Model: Mo-C1	Date: 07-Dec-12	No.: RD124001f
--------------	-----------------	----------------

Subject: Firmware Release Note: Engine		Prepared by: Y. Kurohashi	
From: 2nd PP Tech Service Sect., PP Tech Service Dept.			
Classification:	<input type="checkbox"/> Troubleshooting	<input type="checkbox"/> Part information	<input checked="" type="checkbox"/> Action required
	<input type="checkbox"/> Mechanical	<input type="checkbox"/> Electrical	<input type="checkbox"/> Service manual revision
	<input type="checkbox"/> Paper path	<input type="checkbox"/> Transmit/receive	<input type="checkbox"/> Retrofit information
	<input type="checkbox"/> Product Safety	<input checked="" type="checkbox"/> Other (Firmware)	<input checked="" type="checkbox"/> Tier 2

Model: Mo-C1		Date: 12-Mar-13	No.: RD124020
Subject: New SP mode: SP3112-10 (Plotter Emergency Stop)		Prepared by: F. Noguchi	
From: 2nd PP Tech Service Sect., PP Tech Service Dept.			
Classification:	<input type="checkbox"/> Troubleshooting	<input type="checkbox"/> Part information	<input type="checkbox"/> Action required
	<input type="checkbox"/> Mechanical	<input type="checkbox"/> Electrical	<input checked="" type="checkbox"/> Service ma

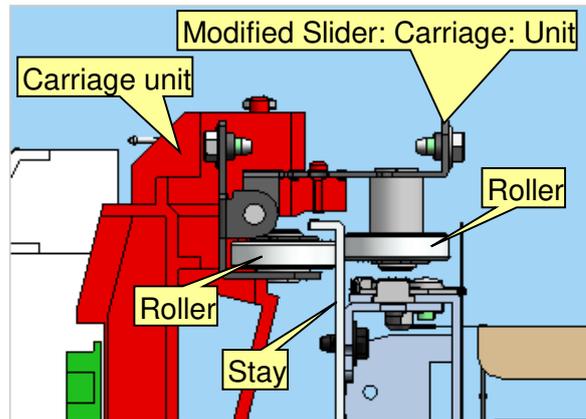
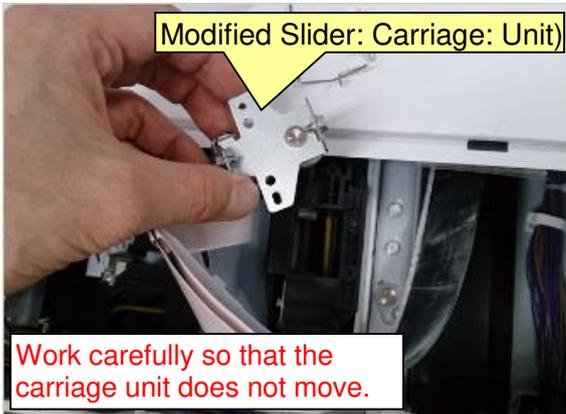
9. Install the modified Slider: Carriage: Unit so that its roller nips the stay. See the illustration to the right to install the modified Slider: Carriage: Unit.

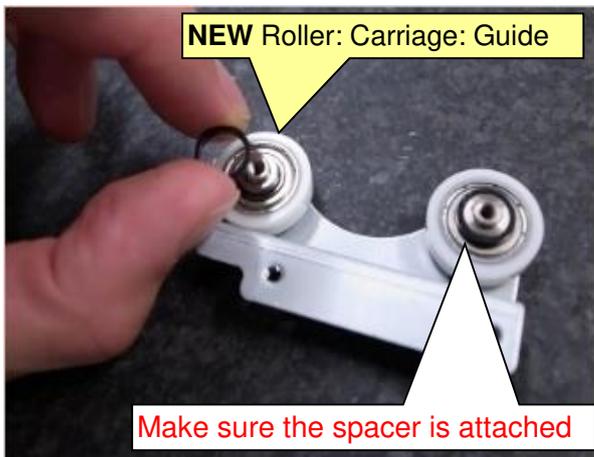
- 8. Attach the new (countermeasure) Roller: Carriage: Guide to the support bracket.

Material 2 (mylar sheet and retainer)

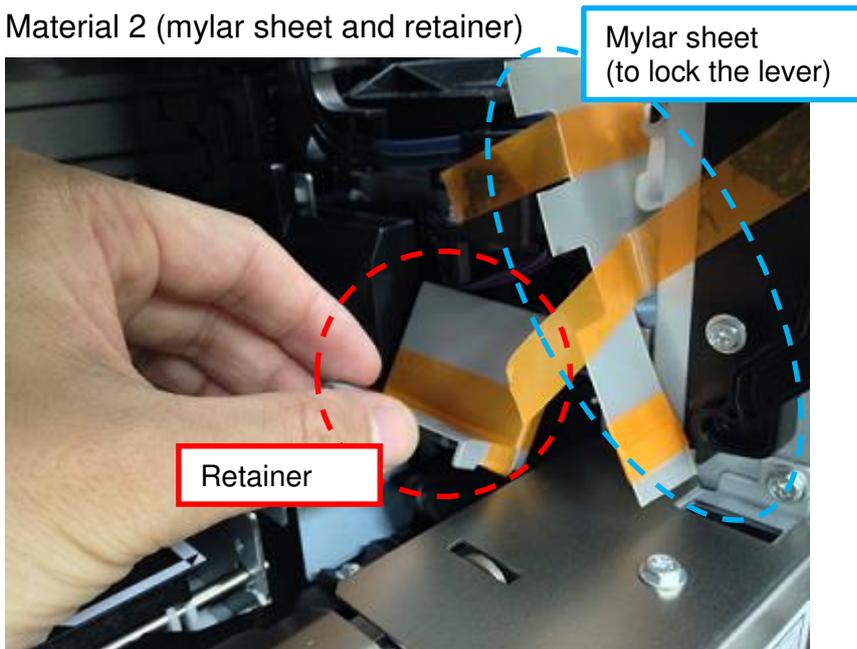
The procedure for removing tape and shipping materials was changed as follows (Step 4 was revised).

**Note:** Protective shipping materials were added to the area inside the front cover shown below. This was done to further protect the area from any shock or vibration during transport.

4. Remove the following materials (1 and 2).

d124r752

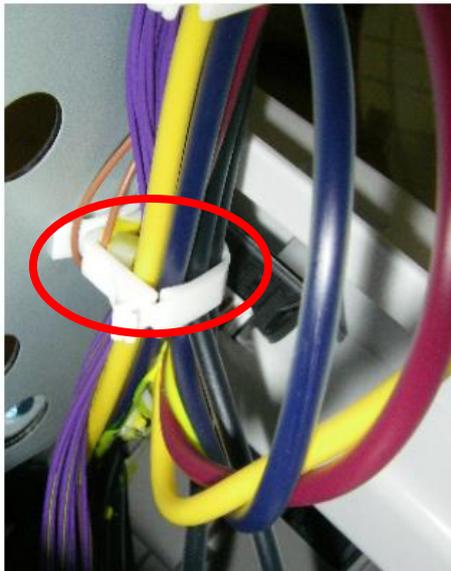
On page 458, delete the ink cartridges from the list of accessories, as the ink cartridges are no longer included as an accessory.

No.	Item	Q'ty
1.	Ink Supply Unit (ink tubes attached)	1
<del>2.</del>	<del>Ink Cartridges (K, C, Y, M)</del>	<del>4</del>
3.	Ink Sump	1
4.	Ink Sump Cap	1
5.	Rubber Caps	5
6.	Plugs	15

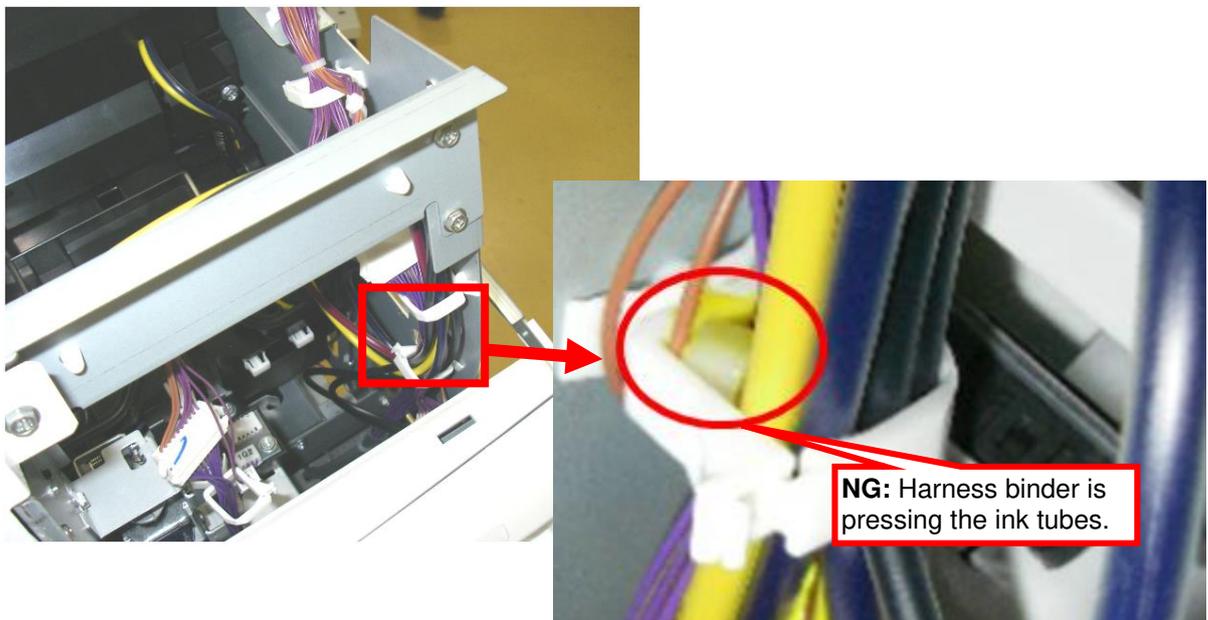
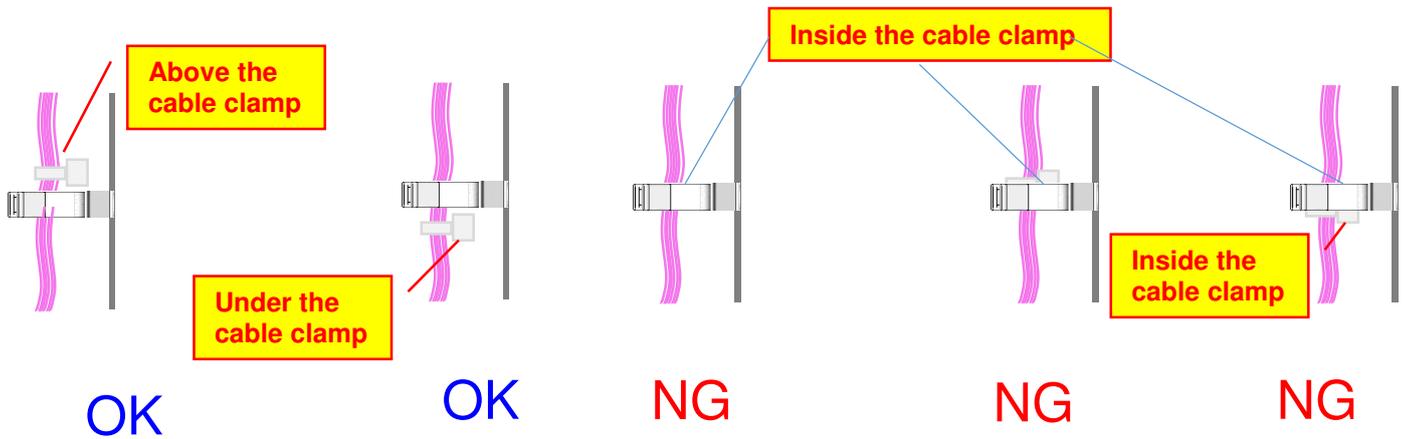
2. Check the position of the harness.

- OK : The binder is positioned either under or above the cable clamp.
- NG : The binder is positioned inside the cable clamp.

If the harness binder position is NG, unlock the cable clamp and shift the position of the harness binder either above or under the clamp

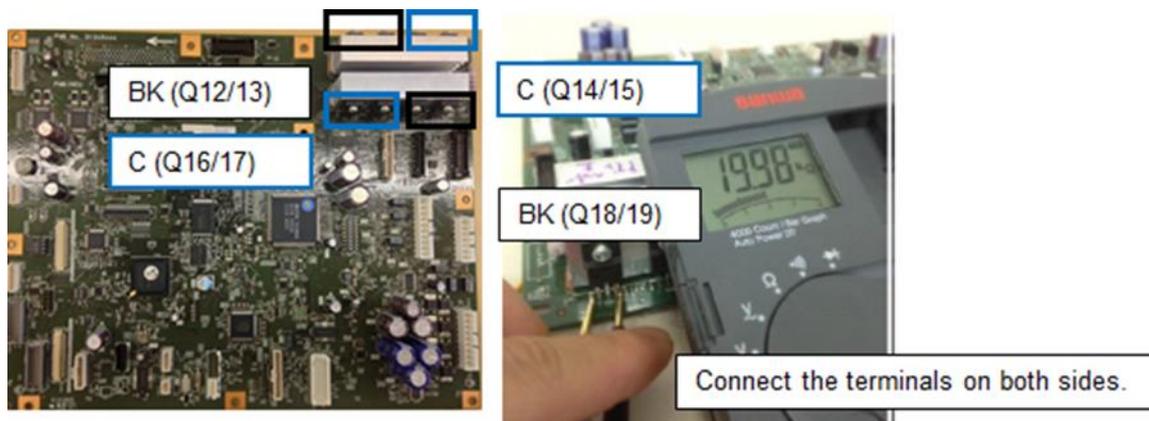
**3. Measure the resistance level to check if PwTr on MCU is short circuited or not.**

- **Normal range** : 19kΩ ~ 21kΩ
- **Abnormal range (short circuit)** : 0.1Ω ~ 0.9Ω

**BK print head does not have to be replaced, if Q12/Q13/Q18/Q19 are all within normal range. (Replace only Color print head.)**

**Color print head does not have to be replaced, if Q14/Q15/Q16/Q17 are all within normal range. (Replace only BK print head.)**

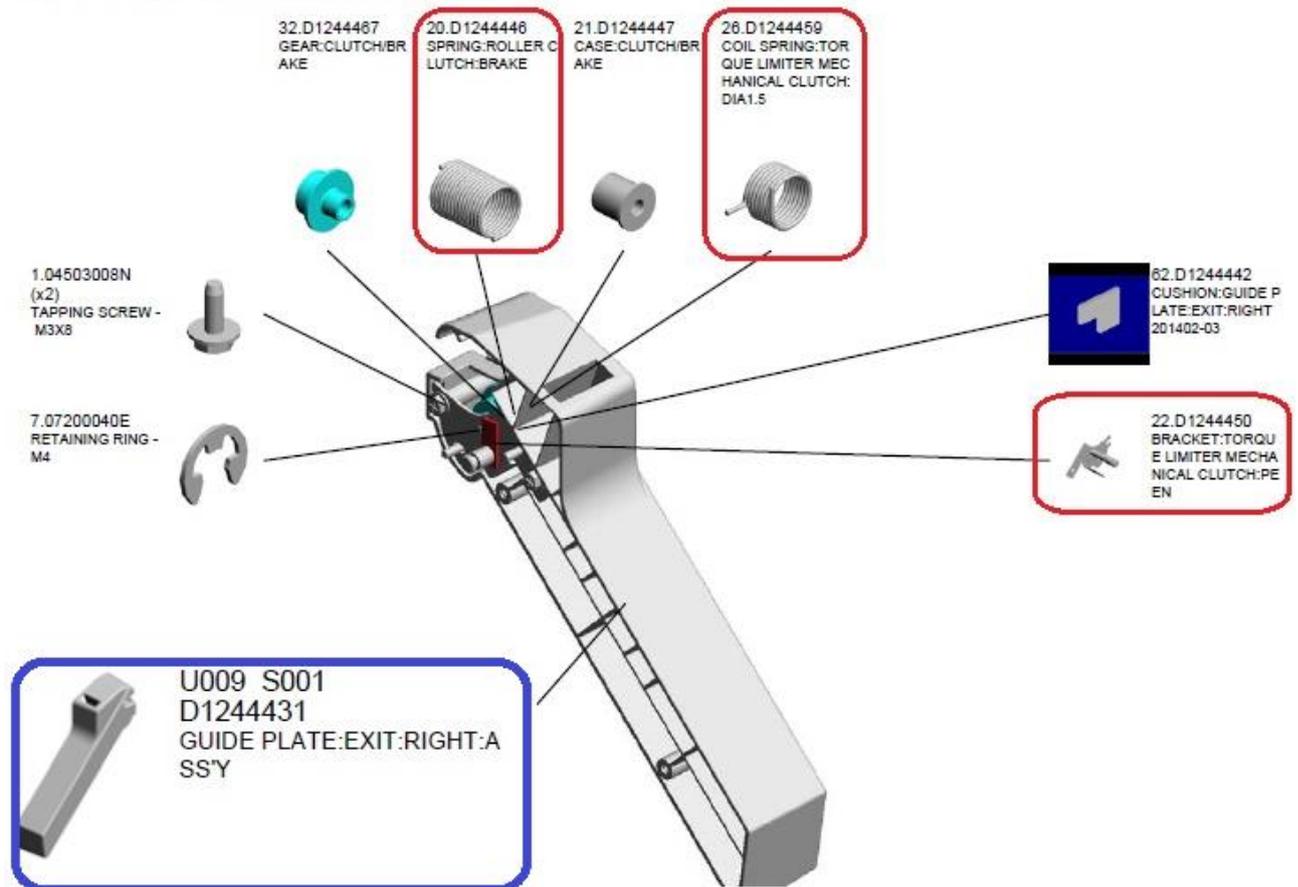
For higher durability

Part Description	Old Part Number	New Part Number	Page Number in P/C
GUIDE PLATE:EXIT:RIGHT:ASS'Y	-	D1244431	U009 PAPER EXIT S001
BRACKET:TORQUE LIMITER MECHANICAL CLUTCH:PEN	D1244450	Delete	U009 PAPER EXIT 23
SPRING:ROLLER CLUTCH:BRAKE	D1244446	Delete	U009 PAPER EXIT 21
COIL SPRING TORQUE LIMITER MECHANICAL CLUTCH:DIA1.5	D1244459	Delete	U009 PAPER EXIT 27

The modification has been applied to mass production since Sep, 2013.

**Reinstallation / Replacing**

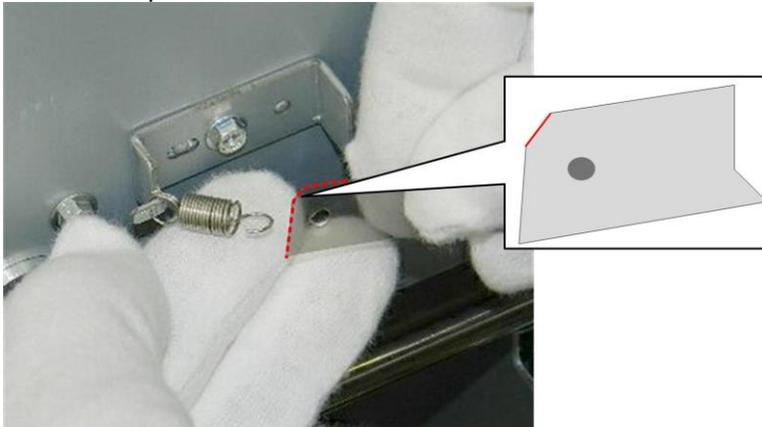
Please add the following notes in **blue** to the field service manual in section:

- Before reinstallation, inspect the encoder strip. If it is dirty, clean it with an alcohol damp cloth, and then dry it with a dry linen cloth.
